Project Number: SP2018-005
Project Name: 615 Highland Drive
Project Type: SITE PLAN
Applicant Name: HUCKABEE
Owner Name: ROCKWALL, I S D
Project Description:

SP2018-005 -SITE PLAN FOR REINHARDT ELEMENTAR SCHOOL
SITE PLAN - LOCATION MAP =

Discuss and consider a request by Crystal Vasquez of Huckabee on behalf Will Salee of the Rockwall Independent School District for the approval of a site plan for a school on a 6.983-acre parcel of land identified as Lot 1, Block A, Rockwall School Addition #2, City of Rockwall, Rockwall County, Texas, zoned Single Family 10 (SF-10) District, addressed as 615 Highland Drive, and take any action necessary.

ELECTRICAL
PHOTOMETRIC SITE PLAN

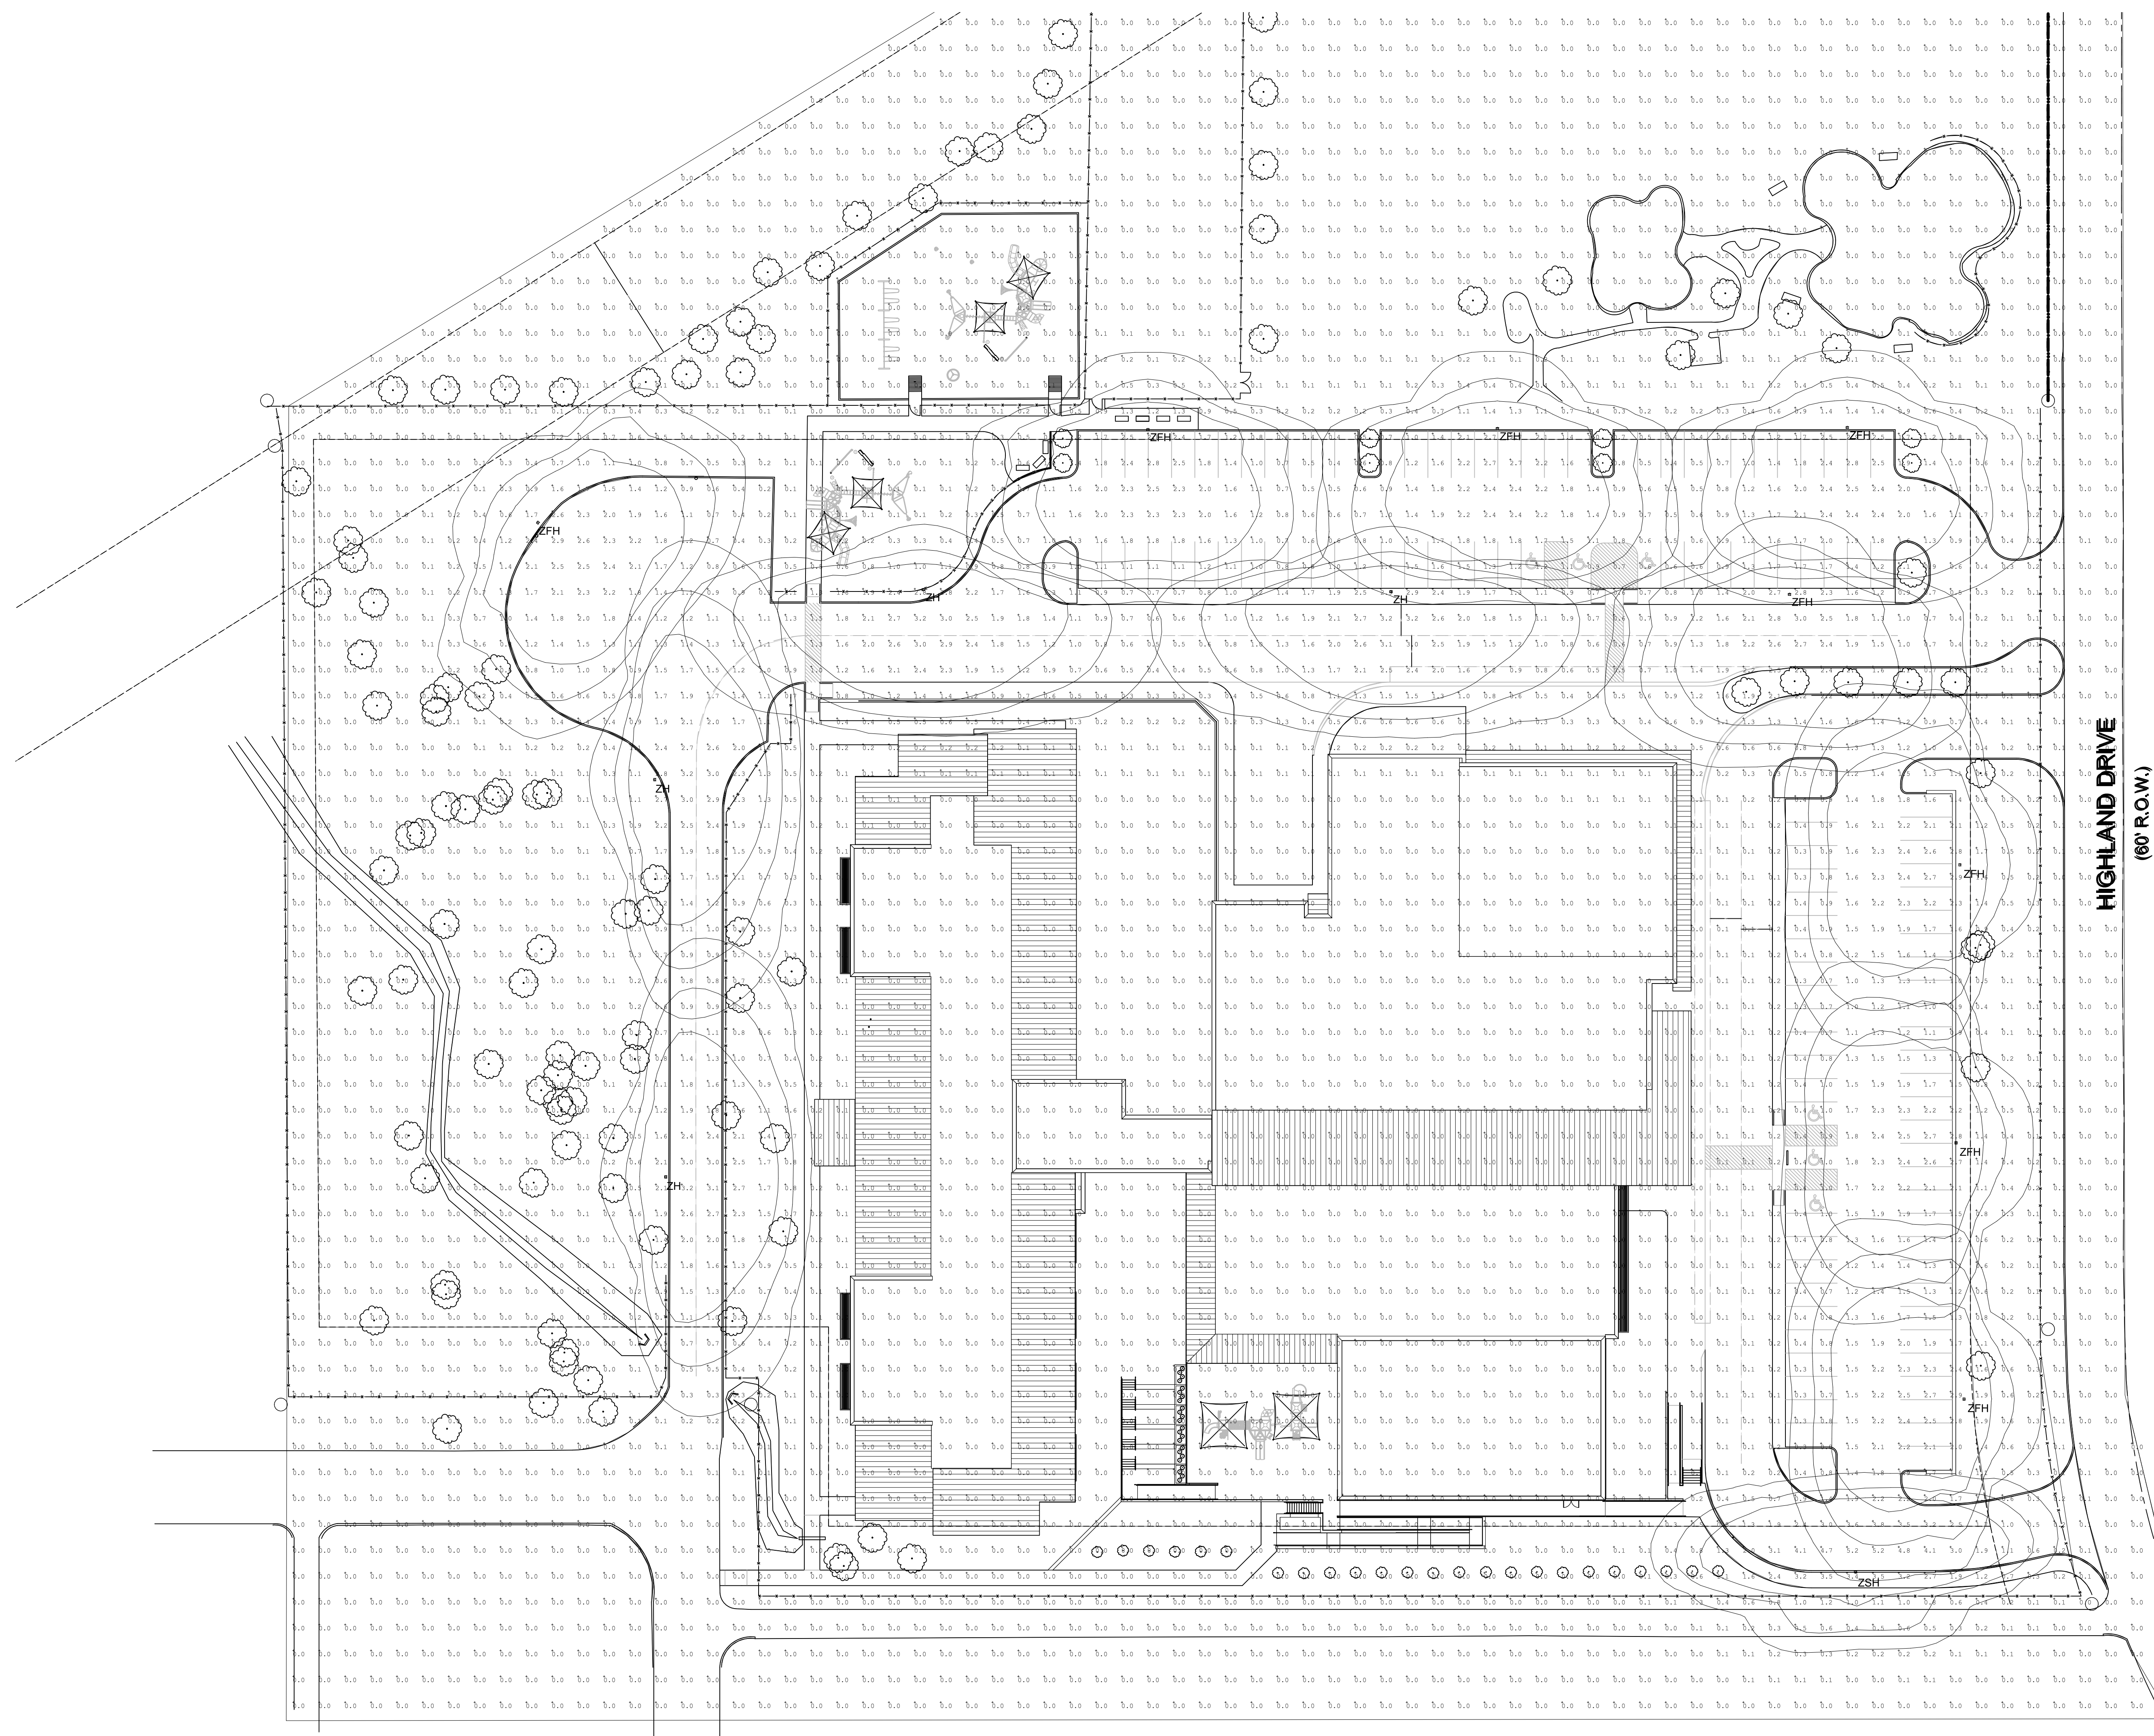
1. Meets or exceeds the intent of the UDC as submitted						
Treescape Plan:						
<ol style="list-style-type: none"> 1. The treescape plan as submitted meets or exceeds the requirements of the UDC 2. How will you satisfy the mitigation balance of 599-caliper inches? 						
Photometric Plan:
